**STAFF RECOMMENDATION**

**311 Chapel Avenue**

**August 21, 2019**

**Application:** New Construction—Outbuilding/Detached Accessory Dwelling Unit

Figure 3: Rendering showing roof form and dormer

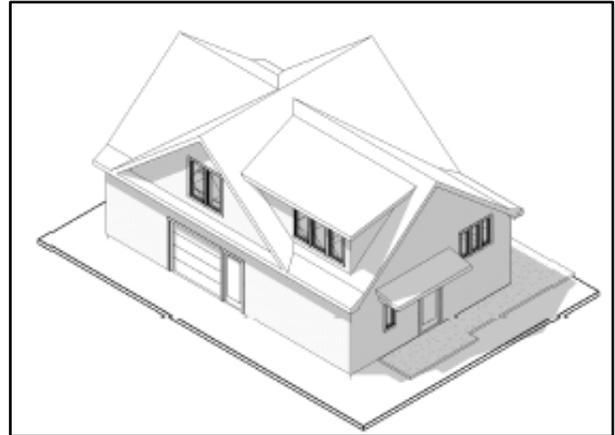
The primary roof form is cross gabled, which is appropriate. A shed dormer on the interior side elevation occupies less than fifty percent (50%) of the wall plane and is inset the required two feet (2') from the wall below Figure 3).

Staff finds that the proposal meets the Section II.B.h.1 of the design guidelines for roof form.

Figure 4: Site plan

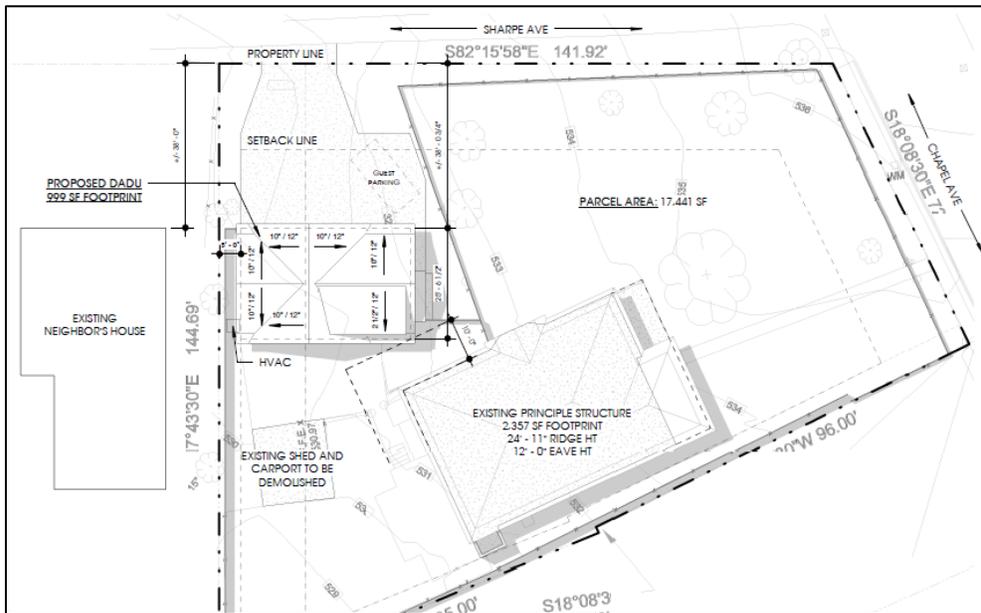
The odd shape of the lot and the deep front setback of the primary structure create a unique challenge for site planning and setbacks (Figure 4). The base zoning requires a twenty foot (20') setback from the side street when the garage doors face the street. However, the historic houses along Sharpe Avenue are setback much further, at approximately thirty-eight feet (38') from the street (Figure 5). Additionally, the guidelines require a twenty foot (20') distance between the house and DADU. Given the location of the house in relation to Sharpe, a twenty foot (20') distance would push the DADU into the setback. The applicant worked with staff to design the proposal presented here wherein the DADU's setback will align with the historic houses along Sharpe, and a ten foot (10') distance to the primary structure will be provided. The Commission has reduced this distance to ten feet (10') in previous cases where there were unusual lot restraints.

Staff finds that when viewed as a whole, these proposed setbacks are appropriate to this specific site and that the project as proposed meets Section II.B.h.2 of the guidelines for setbacks and site requirements.

SITE PLAN

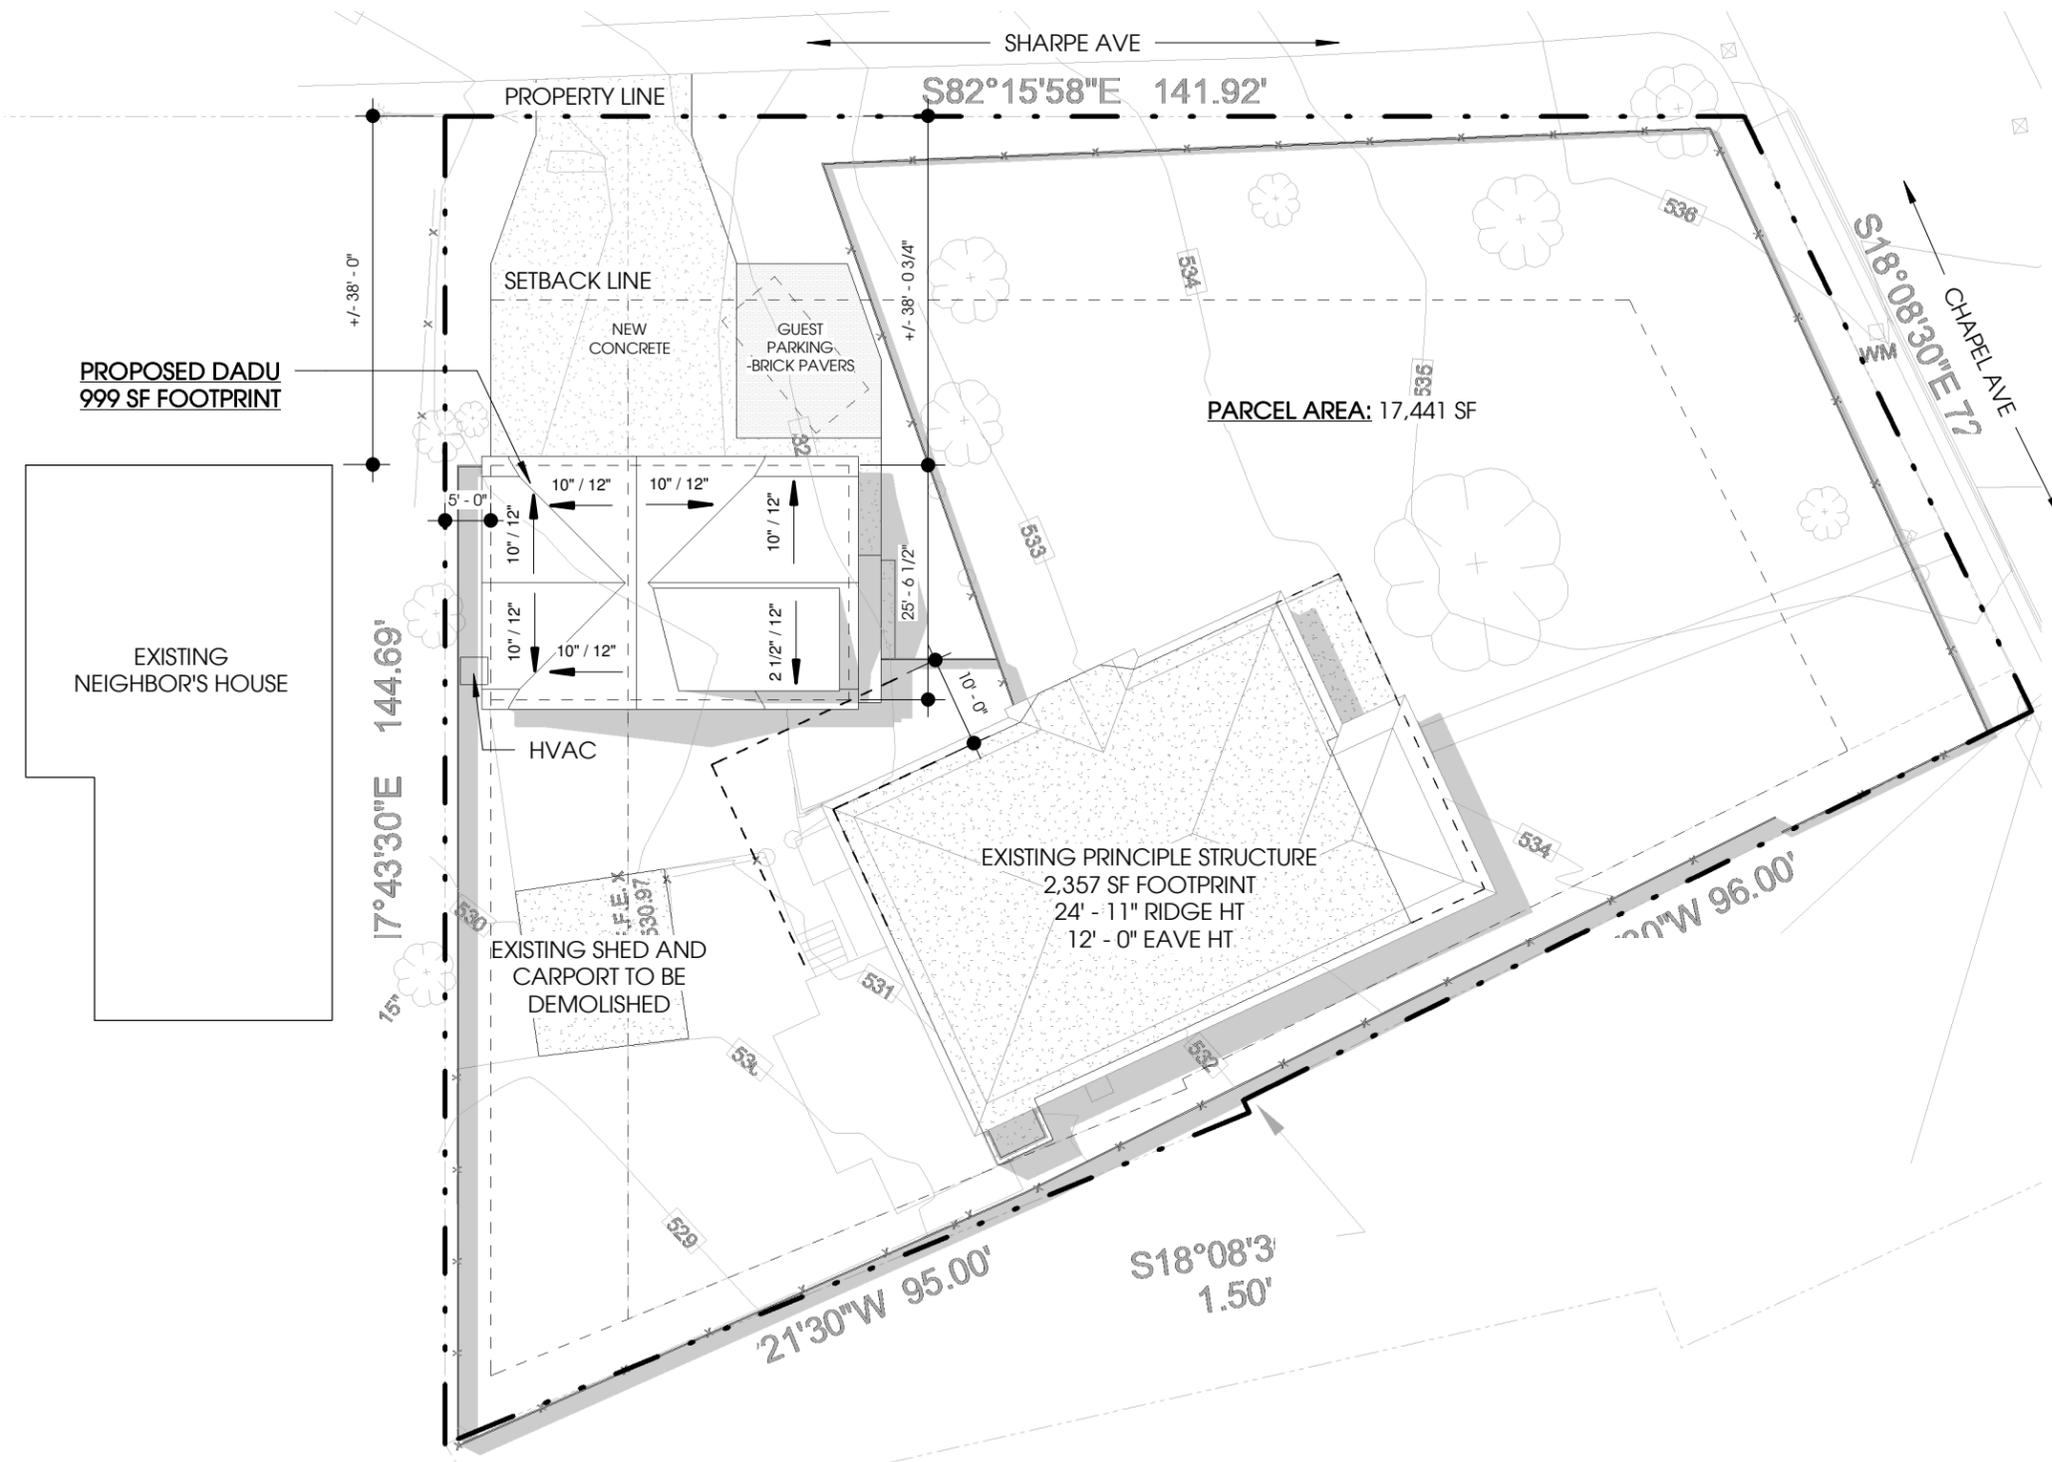
|  | MINIMUM | PROPOSED    |
|--|---------|-------------|
| Space between principal building and garage                        | 20'     | 10'         |
| Rear setback   | 3'      | 5'          |
| Side street side setback – garage doors face street                | 20'     | ~38'        |
| Interior side setback  | 5'      | +60'        |

ELEVATIONS

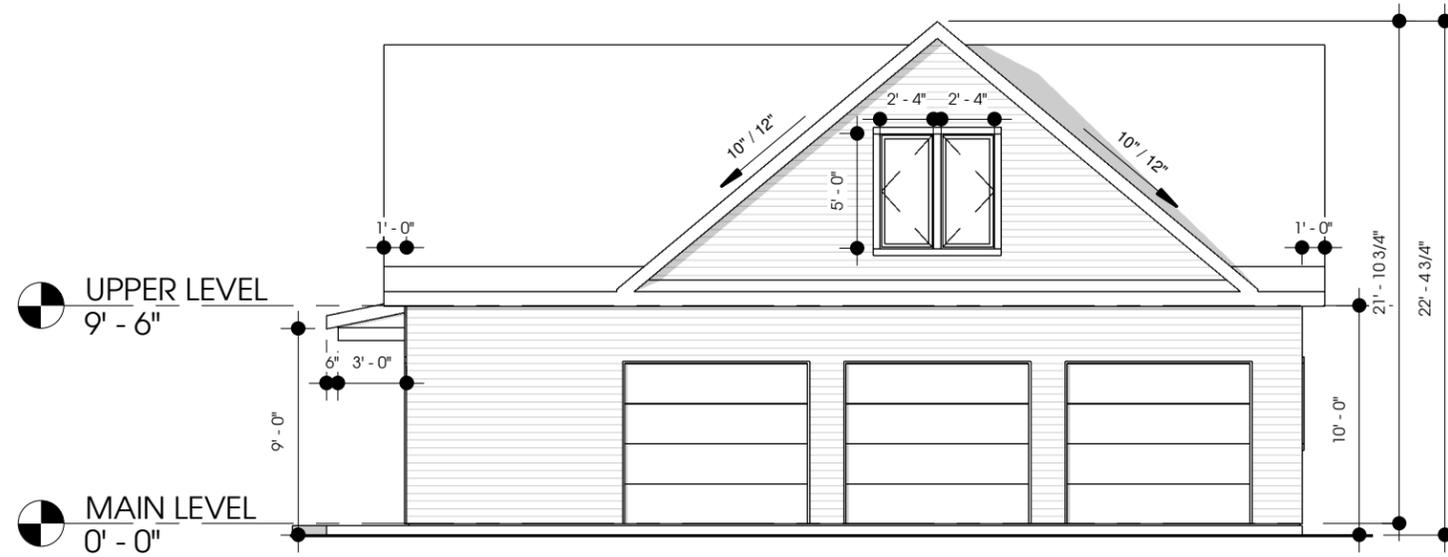
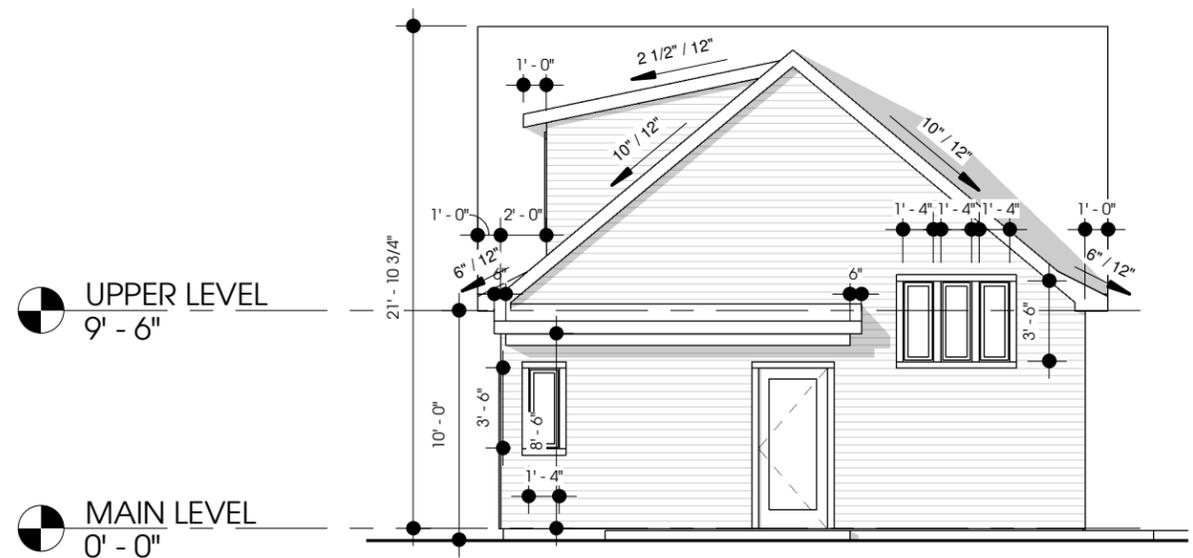
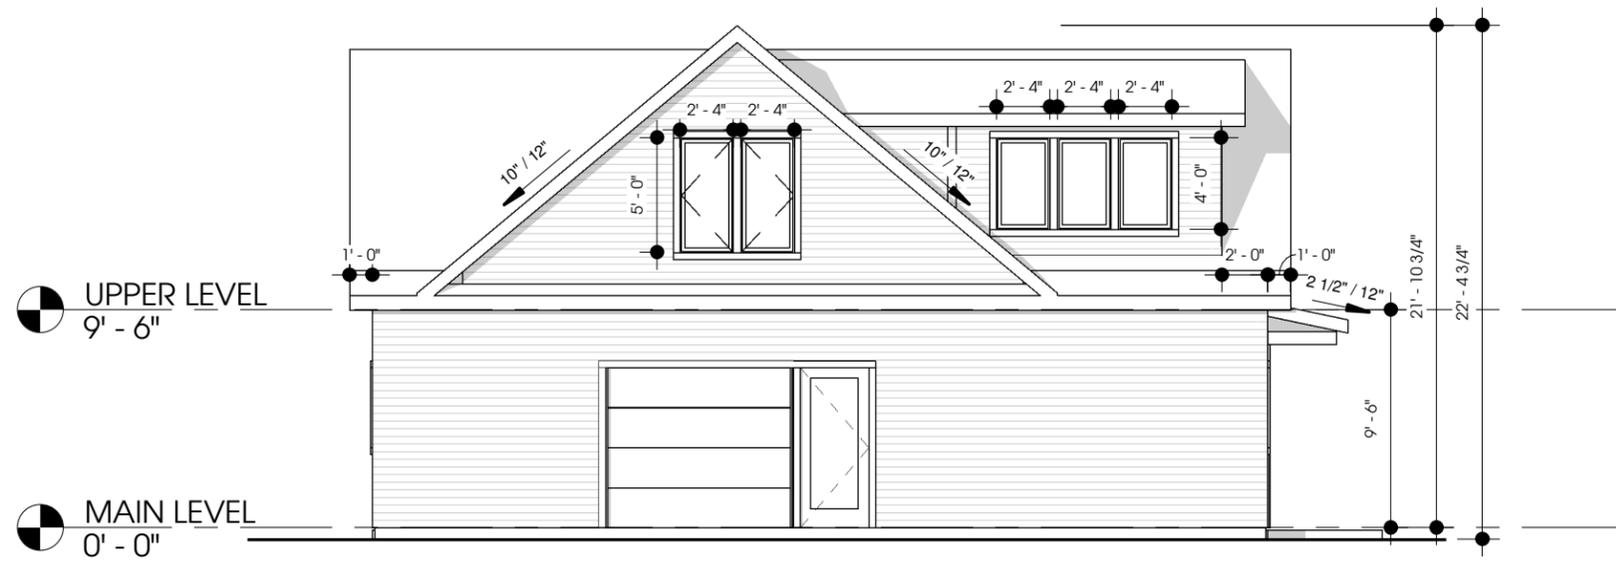
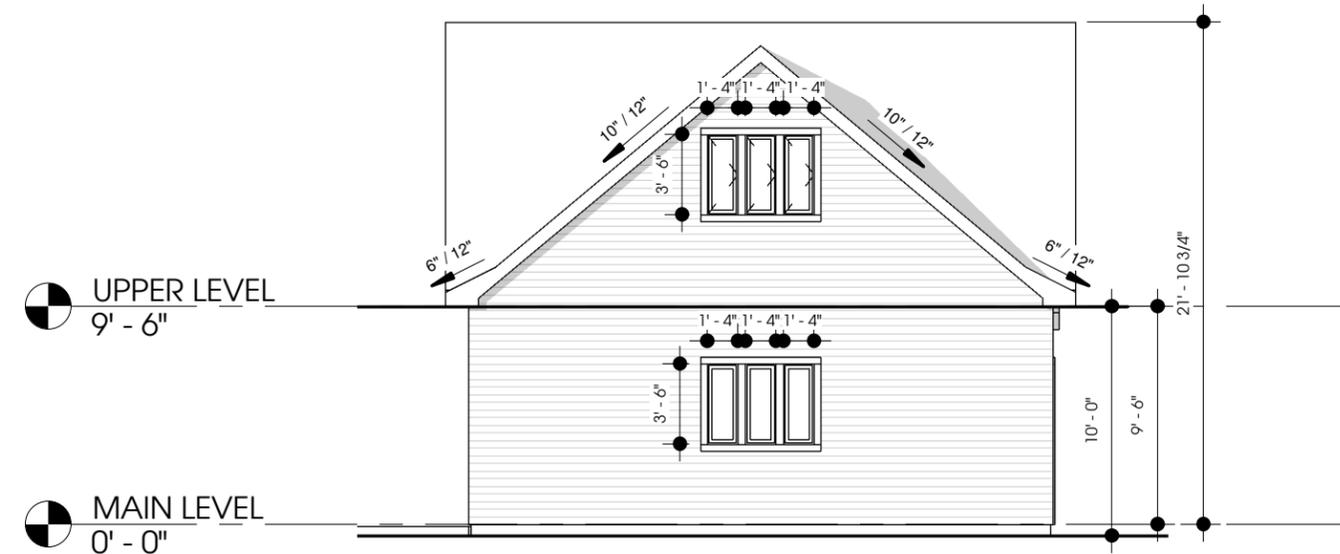
|               | <b>Proposed</b> | <b>Color/Texture</b>            | <b>Needs final approval?</b> |
|---------------|-----------------|---------------------------------|------------------------------|
| Cladding      | Siding          | Material/exposure not indicated | Yes                          |
| Windows       | Not indicated   | Need final approval             | Yes                          |
| Doors         | Not indicated   | Need final approval             | Yes                          |
| Garage door   | Not indicated   | Need final approval             | Yes                          |

**Recommendation Summary:** Staff recommends approval of the proposed outbuilding with the condition that staff shall approve the cladding and the final window, pedestrian door and garage door selections, prior to purchase and installation.
